Subject: Approve Resolution No. 3335: Oak Ridge Elementary School Rebuild Project (MND)

OAK RIDGE ELEMENTARY SCHOOL REBUILD PROJECT

August 2023 | **Errata** State Clearinghouse No. 2023060577

COMMENTS TO REQUEST FOR REVIEW FOR THE MITIGATED NEGATIVE DECLARATION, OAK RIDGE ELEMENTARY SCHOOL REBUILD PROJECT, SCH#2023060577, SACRAMENTO COUNTY

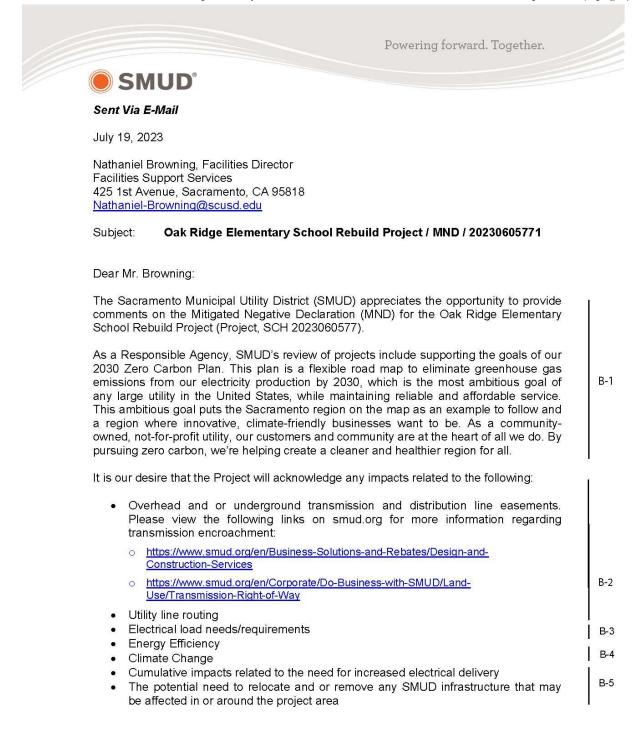
A-6 The commenter states that if the proposed project includes construction or groundwater dewatering to be discharged to land, the proponent may apply for coverage under State Water Board General Water Quality Order (Low Threat General Order) 2003-0003 or the Central Water Board's Waiver of Report of Waste Discharge and Waste Discharge Requirements (Low Threat Waiver) R5-2018-0085.

> Dewatering is not anticipated for the proposed project as the seasonal high groundwater elevation is estimated to be at least 20 feet below grade and no excavations are planned anywhere near that depth by the proposed project. The project site is currently developed with the existing Oak Ridge Elementary and is located in an urbanized portion of Sacramento. The proposed project consists of rebuilding the elementary school. However, if dewatering activities are needed to construct the proposed project, the District will apply for all applicable permits.
